From: [Hurley, Bobbie](#)
To: [Freeman, Carol](#); [Horton, Ruth M](#)
Subject: FW: Request for farmland conversion impact rating of Clinch River Reactor project
Date: Friday, October 16, 2015 8:43:13 AM
Attachments: [ClinchRiverSMRProject AD1006 10 16 2015.pdf](#)

Figure 4. CRN Site Prime Farmland Soils

FARMLAND CONVERSION IMPACT RATING

PART I (To be completed by Federal Agency)		Date Of Land Evaluation Request 9/30/15			
Name Of Project Clinch River SMR Project		Federal Agency Involved Tennessee Valley Authority			
Proposed Land Use Small modular reactor (SMR) facility		County And State Roane County, Tennessee			
PART II (To be completed by NRCS)		Date Request Received By NRCS 10/8/15			
Does the site contain prime, unique, statewide or local important farmland? (If no, the FPPA does not apply -- do not complete additional parts of this form).		Yes <input checked="" type="checkbox"/>	No <input type="checkbox"/>	Acres Irrigated na	Average Farm Size 88 acres
Major Crop(s) corn	Farmable Land In Govt. Jurisdiction Acres: 19,476 % 8	Amount Of Farmland As Defined in FPPA Acres: 100,596 % 40		Date Land Evaluation Returned By NRCS 10/16/15	
Name Of Land Evaluation System Used LESA	Nam

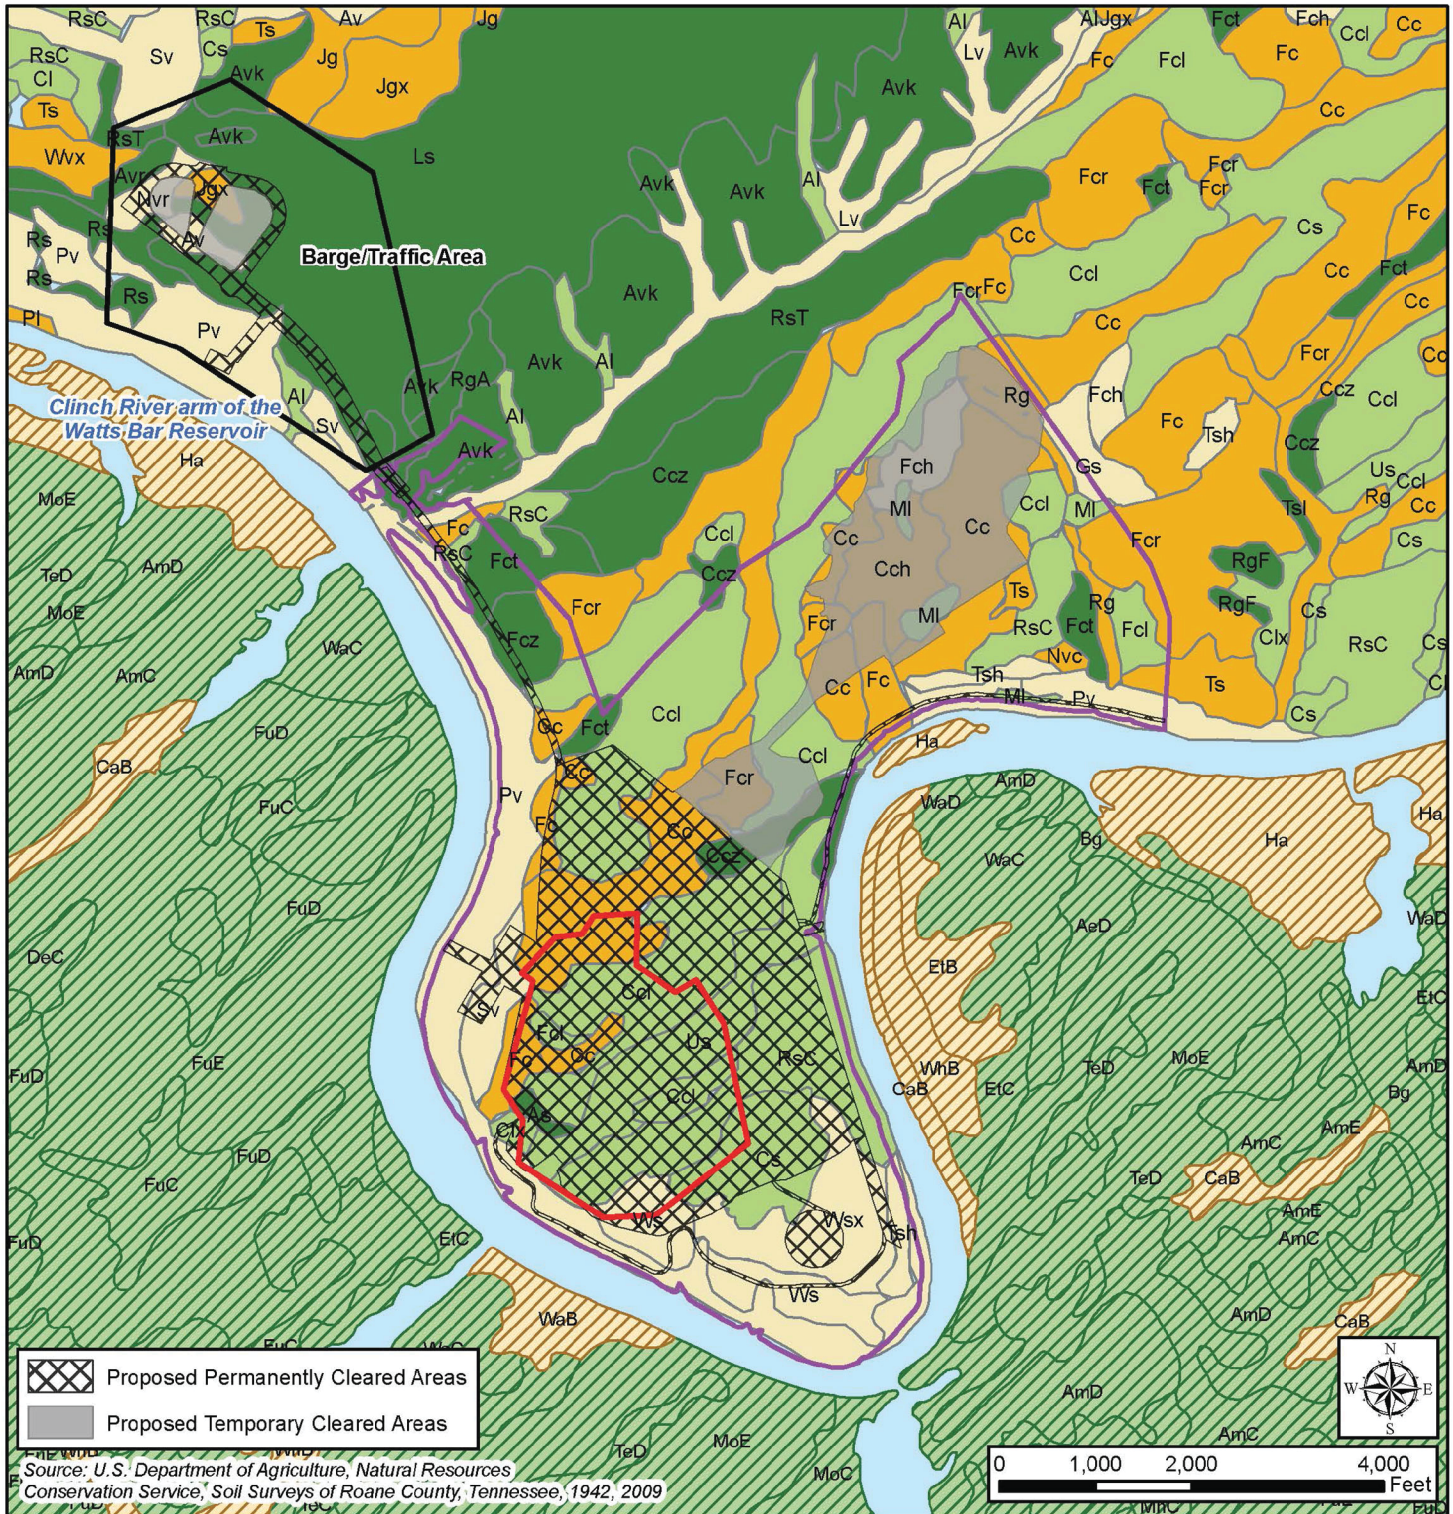
I received your request for Farmland Protection Policy Act (FPPA) review of the Clinch River Reactor project and I need to get a little more information that was not in the documentation that I had forwarded to me. On the enclosed AD-1006, you have listed that the entire 1131 acres will be converted and I wanted to make sure this was correct or is the area that was manipulated in 1983-1984 the area that will be impacted by the overall project (240 acres).

Thank you for your review. Approximately 328 acres would be permanently converted within the

CRN Site, including the entire 240-acre area previously disturbed during the CRBRP. An additional approximately 140 acres within the CRN Site would be temporarily converted as a result of construction activities, mostly to the northeast of the main plant site. Within the offsite Barge/Traffic area approximately 30 acres would be permanently converted (of which approximately 12.1 acres have been previously disturbed) and an additional 15 acres would be temporarily converted. Overall, the entire 935 acres of the CRN site would be unavailable for use as farmland because the site would be restricted access. Much of the Barge/Traffic Area is DOE property that already has restricted access. Attached is a new Figure 4 that shows the permanently and temporarily cleared areas. The GIS files for these are also included for download in the link below. If you need additional information please let me know and we will be happy to assist.
